Access Report

Project –
Long Day Care Centre
84-90 Third Road, Berkshire Park

Design Phase –
Development Application Phase

Date - 8 June 2018
For - Meeks Day Care
Ref - 18239 – Rev 1.1

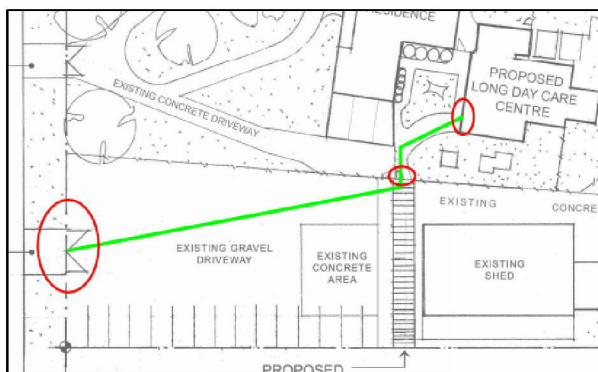
- An accessible pedestrian path of travel is required between the point of entry at the allotment boundary and the Day Care Centre (extent detailed below).

The doors located in the path of travel (circled in red below) shall be made to comply with AS 1428.1-2009 and the path of travel (outlined in green below) to achieve gradients per AS 1428.1-2009.

- An accessible pedestrian path of travel is required between the accessible carspace and the Day Care Centre. Details to be provided i.e. location of accessible carspace, pathway gradients etc.

If the above cannot be achieved, a BCA Performance Solution shall be obtained for any compliance departures at CC stage.

Compliance is readily achievable at the Construction Certificate design phase.
